AGENDA
CITY OF TAYLOR, TEXAS
PLANNING & ZONING COMMISSION MEETING
CITY HALL COUNCIL CHAMBERS
400 PORTER STREET
TAYLOR, TX
JUNE 9, 2026, 6:00 PM

Planning & Zoning Commission Meeting June 9, 2026 Transmittal Letter

**SHT 1
OF 3**

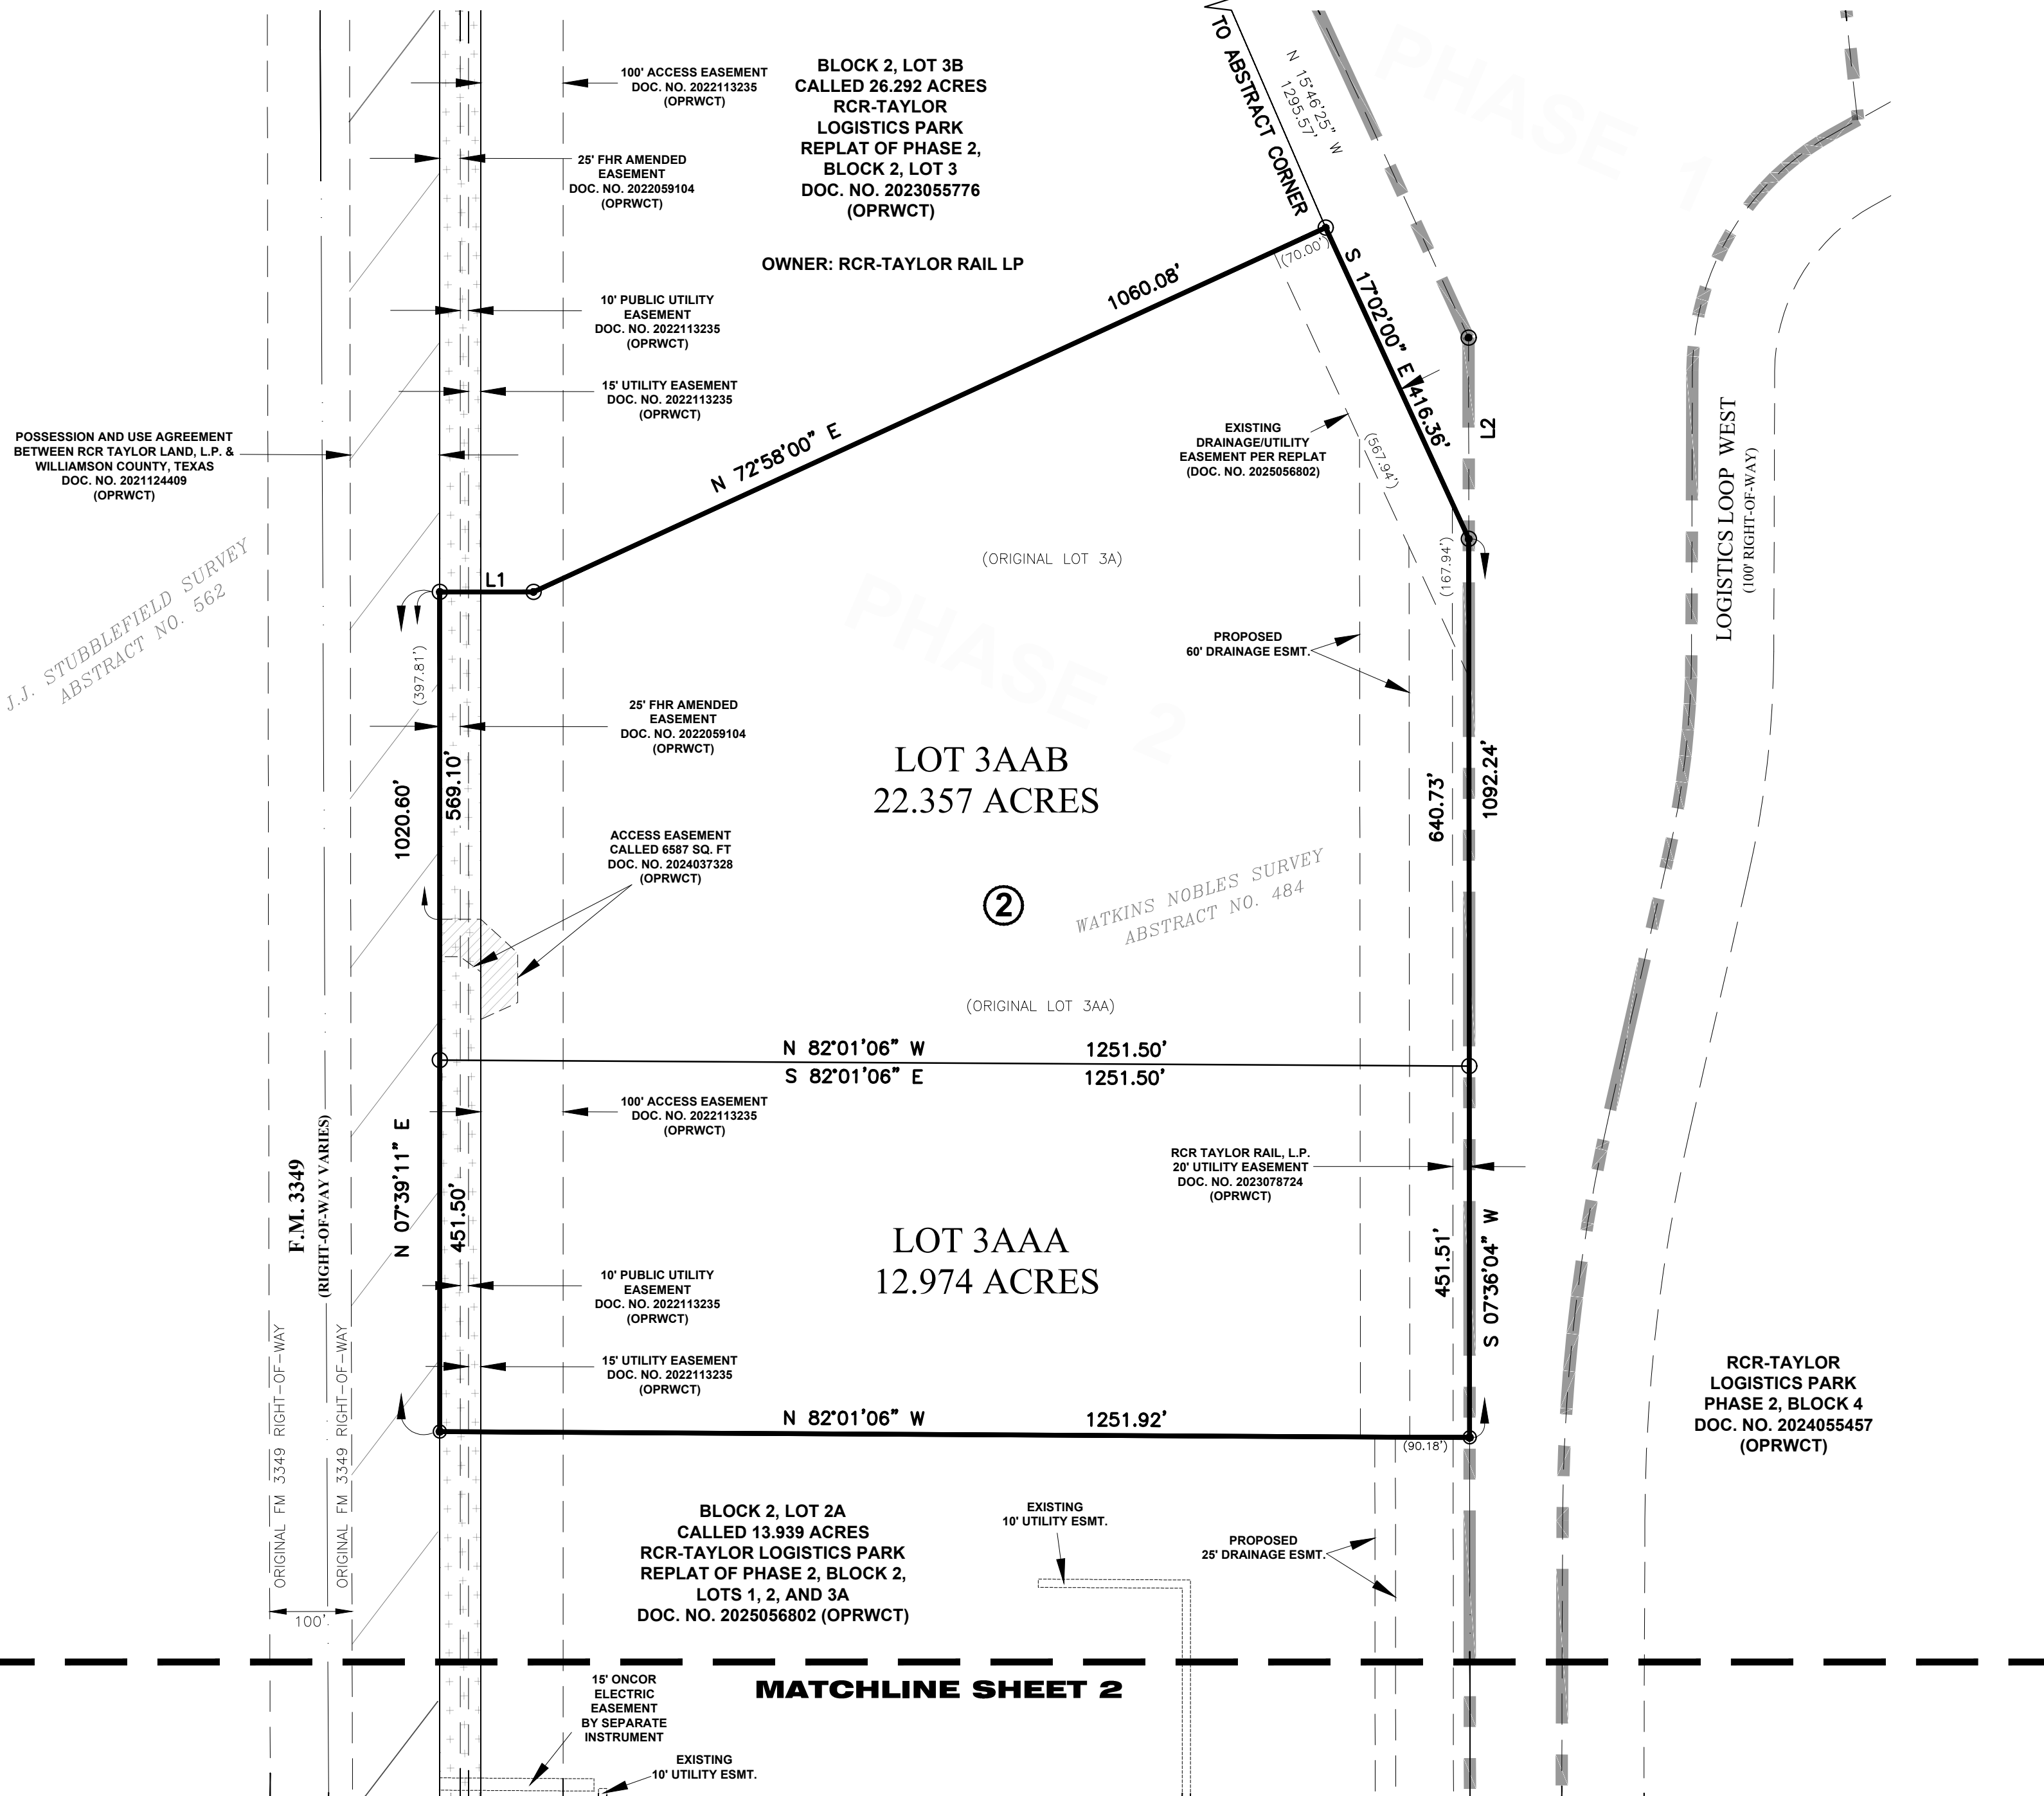
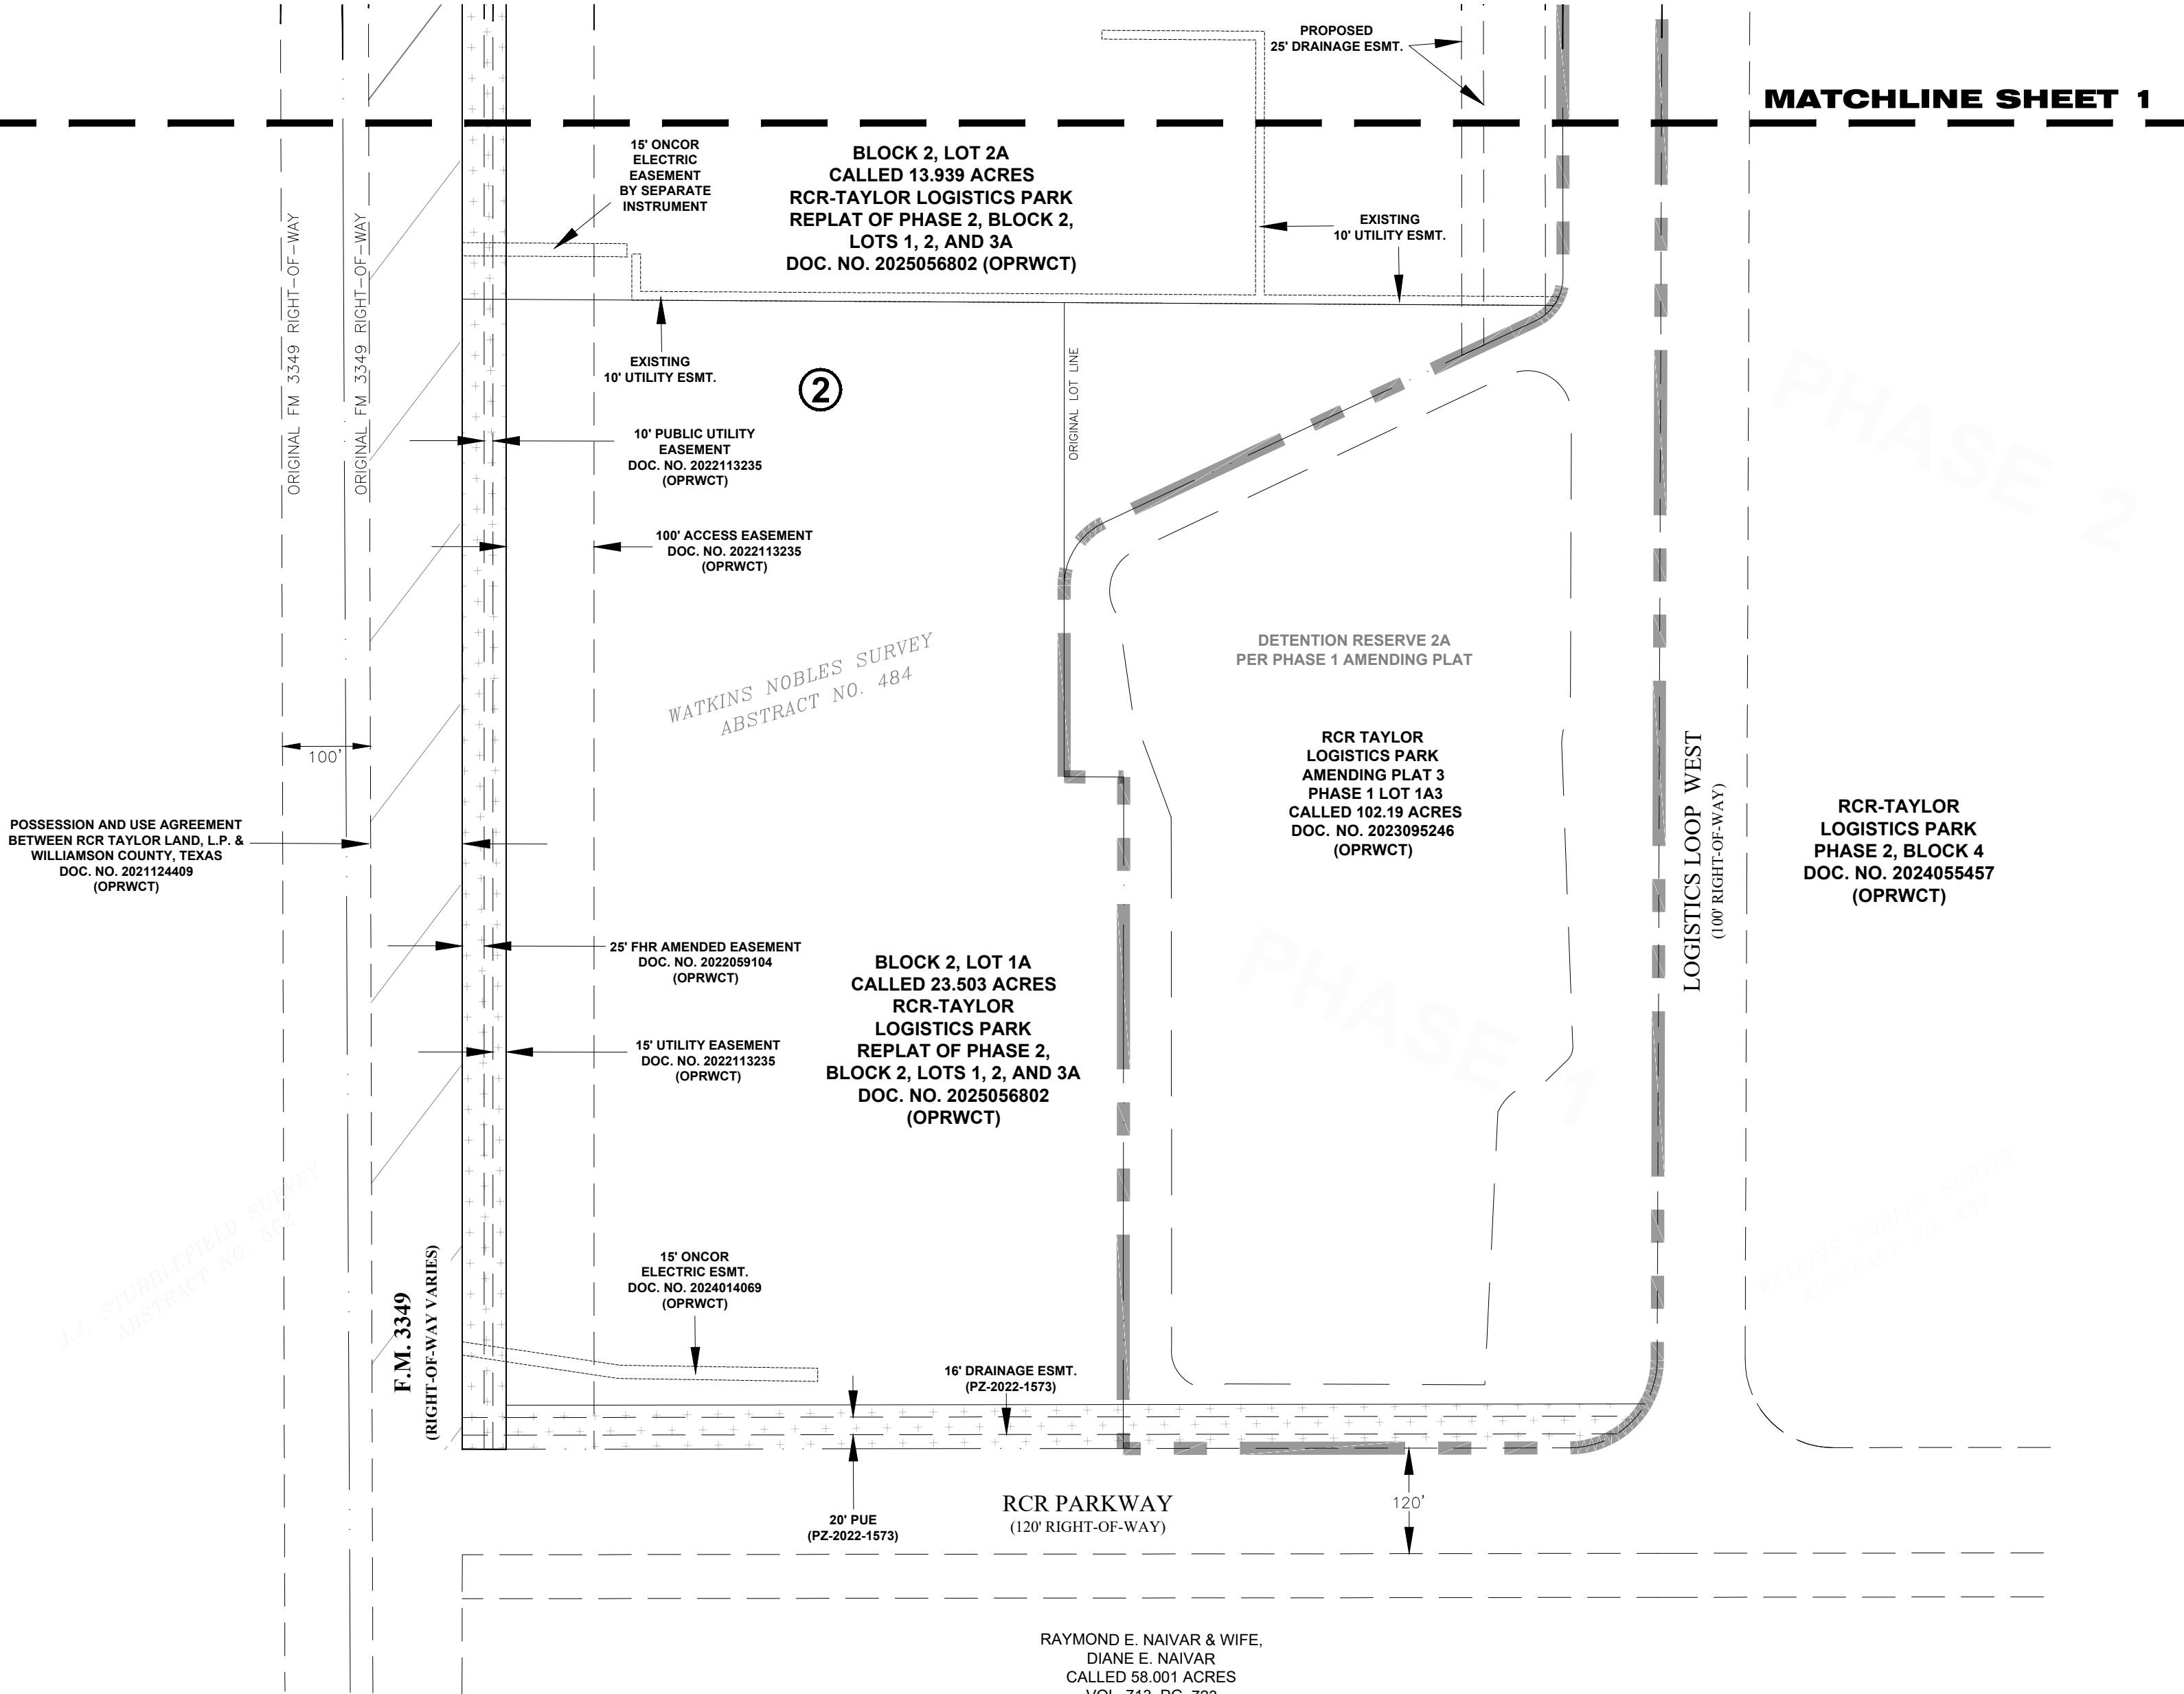
1. [Sheet 1] Block label missing — the plat title references "Block 2" throughout but no block label appears on the drawing itself. Label accordingly.
2. [Sheet 3] For replat, P&Z approval should not be needed and certificate can be removed.

1. Sheet 1 of 3 - Will an easement for the rail portion of the lot be required to tie-in to the existing rail?
2. Sheet 1 of 3 - Show existing railroad.
3. Sheet 1 of 3 - Proposed easement is on Lot 2A. May require owner acknowledgement with this plat or have it completed by separate instrument.
4. Sheet 1 of 3 - Provide a point of beginning on the plat drawing that correlates with the metes and bounds legal description.
5. Sheet 3 of 3 - For replat, P&Z approval should not be needed and certificate can be removed.
6. Sheet 3 of 3 - Include section symbols § for each certificate heading, as applicable (Typical)

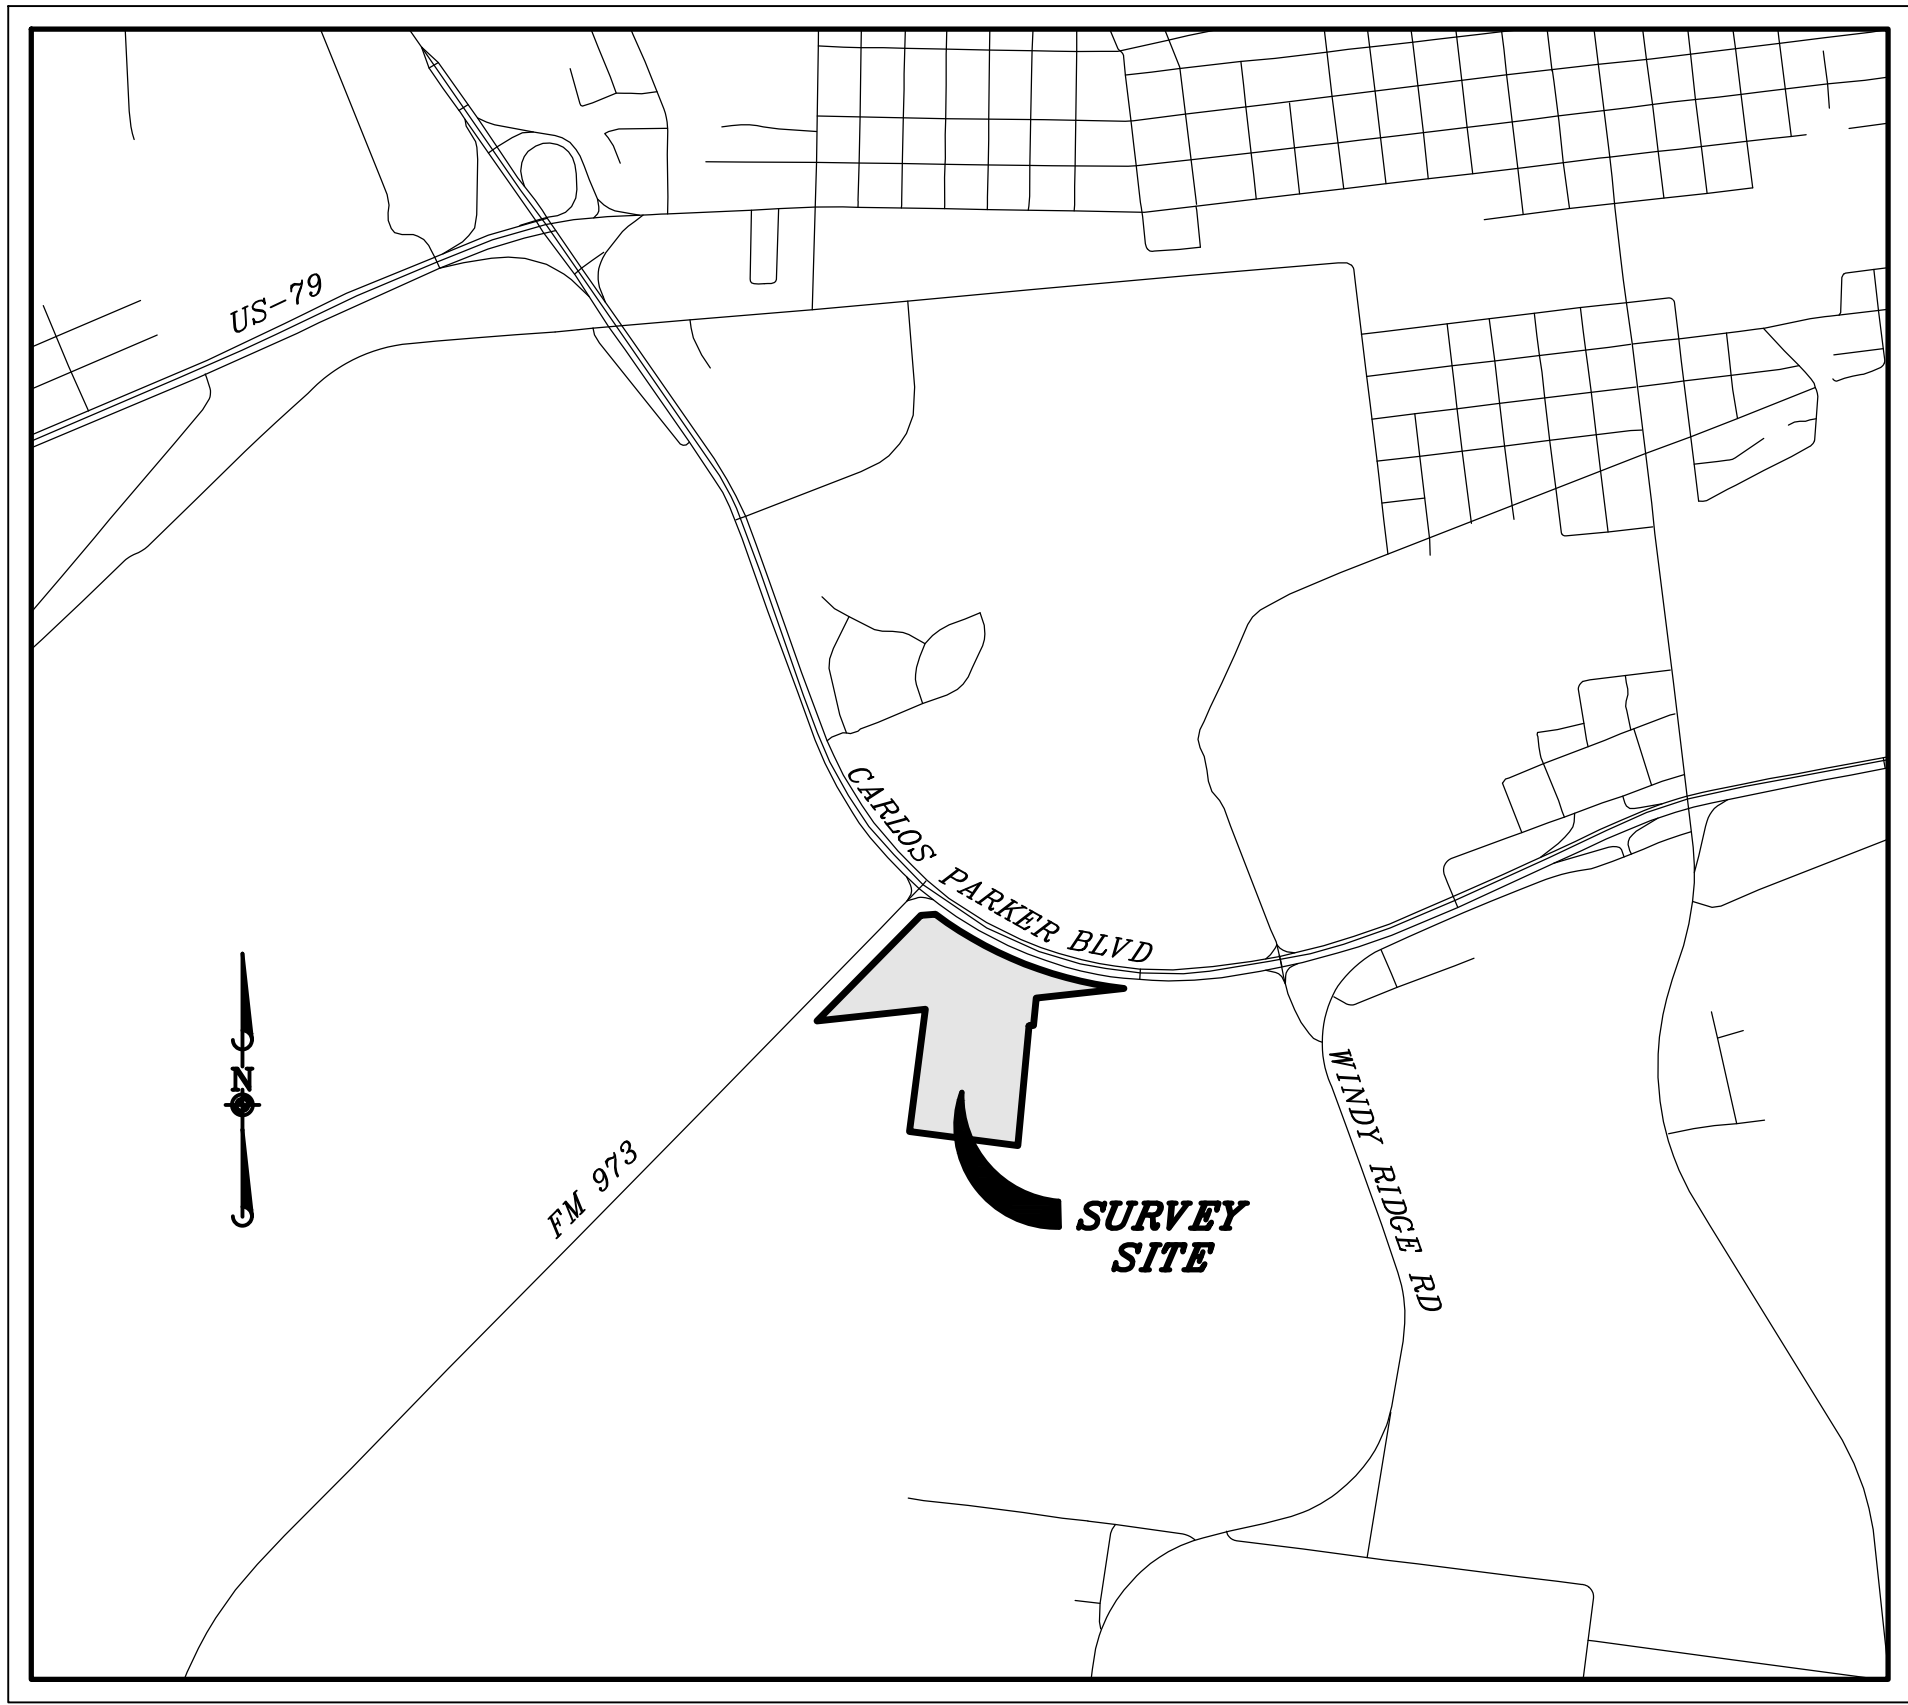
1. [Sheet 1-4] Plat is titled "Subdivision Plat" throughout. Must be retitled "Preliminary Plat" on all sheets.
2. [Sheet 1] Top-center description does not follow the required format. Must include: plat name, total acreage, acres of street dedication, number of lots, number of reserves, survey name and abstract number, and city/county/state. Please correct Preliminary Plat description to read as follows:
"_____ Subdivision Preliminary Plat Being a preliminary plat consisting of ____ acres, including ____ acres of street dedication, To create ____ lots, ____ reserves, part of and out of the _____ Survey, Abstract No. _____, Taylor, Williamson County, Texas"

3. [Sheet 2-3] No easements of any kind (drainage, utility, detention, parks) are labeled or dimensioned on the plat. All existing and proposed easements must be shown and identified.

4. [Sheet 2-3] Limits of construction and site improvements are not delineated on the plat.
5. [Sheet 1] Street 3 is absent from the Street Summary Table. Streets jump from Street 2 to Street 4 with no explanation. Verify and correct.

6. [Sheet 2-3] Lot dimensions and areas are incomplete or illegible on several lots. All lot boundaries must be fully dimensioned and legible on each sheet.

7. [Sheet 2-3] Abutting property information is incomplete. Adjacent tracts must include owner name, acreage, zoning, existing land use, and recording information (document number or volume/page) for all adjoining properties.

8. [Sheet 2-3] No existing or proposed utility infrastructure is shown on the plat. Water, wastewater, and other utilities must be identified, including easements.
